# **INTERNATIONAL CODE COUNCIL**

### **2012 FINAL ACTION AGENDA FOR THE PROPOSED CHANGES TO THE 2012 EDITIONS OF THE**

**INTERNATIONAL BUILDING CODE®**

**October 22<sup>nd</sup>, 24<sup>th</sup> – 28<sup>th</sup>, 2012**

**Figure 1** Residential Range = 7.58" (193mm) – 7.74" (197mm), Commercial Range = 6.84" (174mm) – 7" (178mm) see Table 1 Please note that the described circled ranges have been added to figures 1&2 by the proponent for the purpose of explanation.

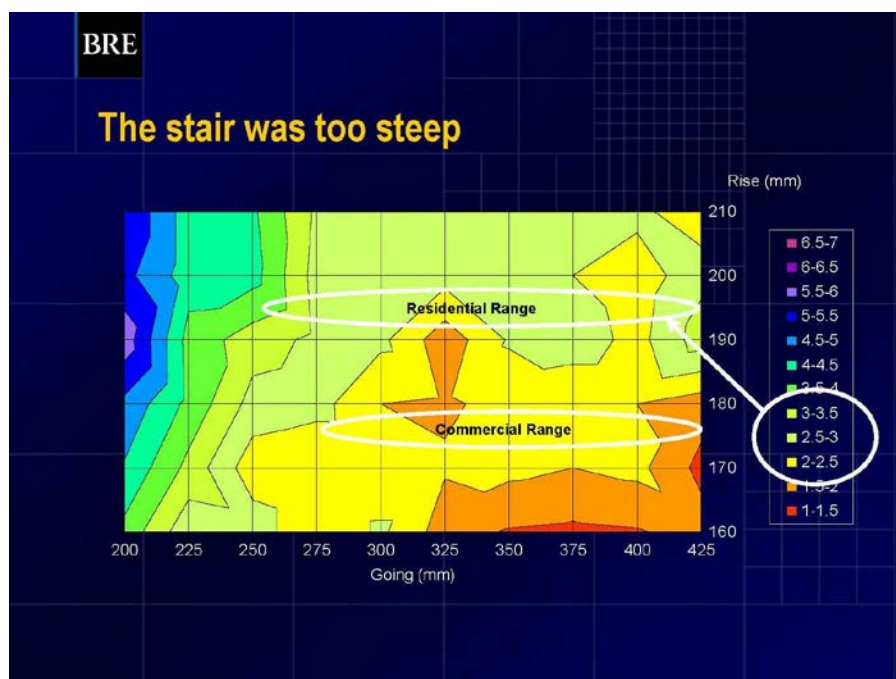
The elevation of 147 inches is a multiple of the maximum riser heights of, 7 inches (178 mm) commercial and 7-3/4 inches (197 mm) residential, allowed for IBC stairways. (See Table 1) This minor change of just 3 inches (76 mm) in the total rise of the flight would in many cases eliminate the cost of incorporating a landing and the space required, in many instances reducing costs of construction. As can be seen in the table below this change would require no additional steps in the stair than the current code requires and a change in riser height of just 5/32 inch (4 mm) or less when the minimum number of risers is desired. This represents no discernable difference consequential to the user.
